From: Village of Cazenovia Mayor

10 October 2016

Memorandum for the Record: Madison County GML Report

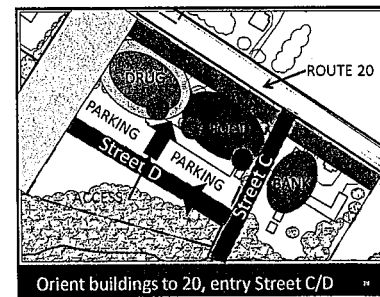
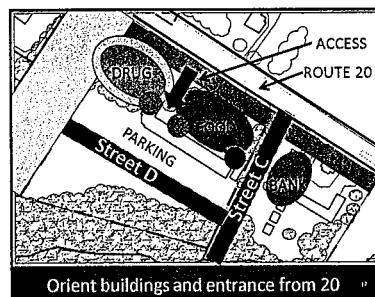
Note: during early discussions with Village the property owner (applicant) mentioned a willingness to provide for a section of street "C" as part of a proposed development.

Note: As site planning has progressed the original potential street "C" alignment has moved to the east to avoid a sensitive section of the wooded central ravine and its watercourse as well as to support the features of the proposed site plan.

**Fourth
Site Plan Considerations**

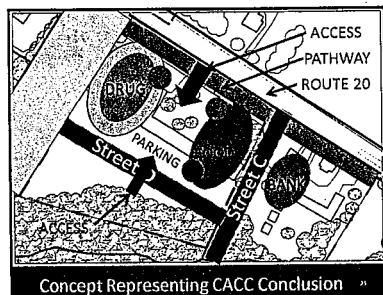
CACC review of the various alternate development plans focused on safety, practicality, constructability, function and sustainability. The applicant's proposed entrance denoted into the parking area between the two main buildings provides several benefits including future safety of traffic ingress/egress for street "C" to residential areas. Looking well into the future if connected to South Meadow and other lands to the south, the ability to segregate the commercial traffic flow from residential for ingress/egress to route 20 is desirable. Queuing on Street "C" alone could create safety issues.

- Applicant's proposed building locations and requested access functions now and for some time in the future.
- Street "C" configuration as proposed should be established as part of the basic development site plan
- Access from a future street "D" should be considered and planned now to function when southeast section of Village develops
- Street "D" can function as part of a parking lot until cross street toward west can be installed

CACC Key Stormwater Control Concern

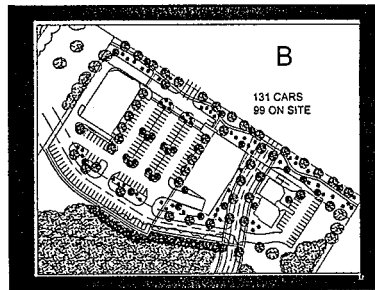
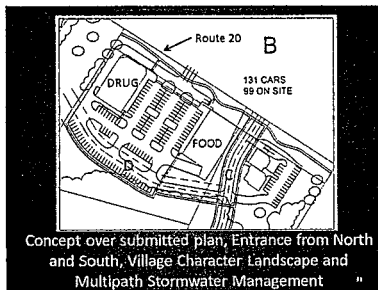
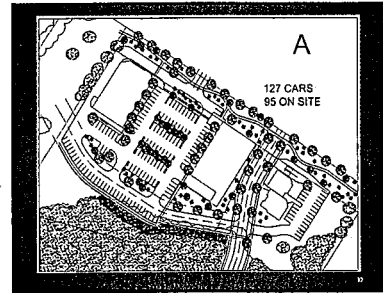
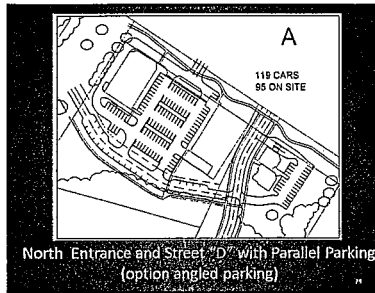
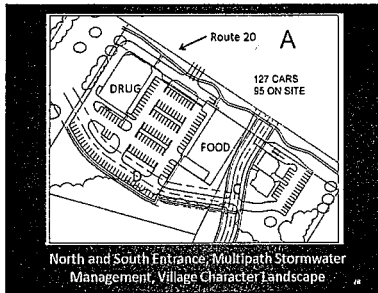
- CACC opinion: proposed site plan has not measurably changed or improved for stormwater runoff control in the Village potable water aquifer zone from the date of land annexation.
- CACC considers engineering approach a basic "end of pipe" system with runoff dumped from collection points and piping into two basins
- CACC recommends Planning Board request the applicant to reconfigure the site plan with a stormwater management system that applies a number of multiple pathways (best way for infiltration)

CACC REVIEW
developed suggestions for consideration
Site Concepts Displayed

CACC CONCLUSION 1
 Site design good for buildings and access but applicant's plans considered deficient

- Pathway (linear park) compromised
- No viable set up for Streets "C" and "D"
- Highway not Village character displayed
- 50% Green Space not fully documented
- End of pipe stormwater management
- Required tree inventory not fully provided
- Reduced parking spaces not fully justified
- Planting plan minimal and weak at best
- No woodland disturbance restoration

CACC CONCLUSION 2
 An approvable site plan should have:

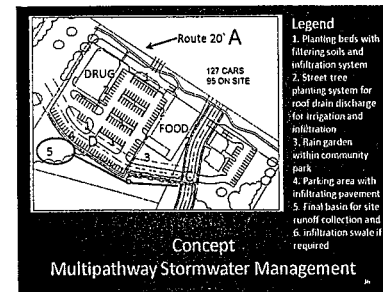
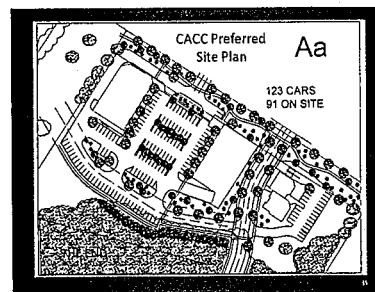
- Pathway (linear park) with entry landscape
- Set up for or built Streets "C" and "D"
- 50% set aside of meaningful Green Space
- Multipathway stormwater management
- Site Access from both north and south
- Reduced number of parking spaces
- Village character for parking court
- Restoration of woodland disturbance
